**DATE:** 03.31.2014  
**TO:** ProTrak  
**FROM:** Bill McDow  
Transportation Planning

■ **ST MARY’S PARISH TILESTON CAMPUS [Initial Plan Review]**

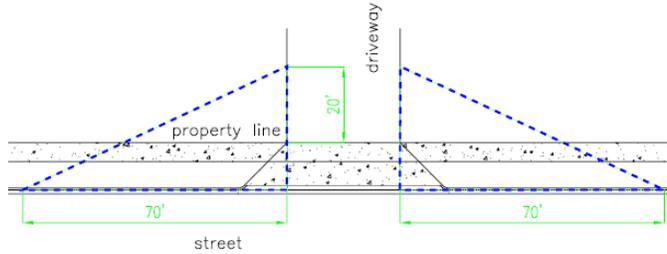
1. Driveways along side streets not classified as a major thoroughfare must have corner clearance of 60’ measured along the curb line. The proposed driveway and driveway flare appears to be too close to the stop sign. Please reduce taper for the driveway flare to ~6’ to allow for additional distance between the driveway and the stop sign. [\[7-13 CofW Tech Stds\]](#)
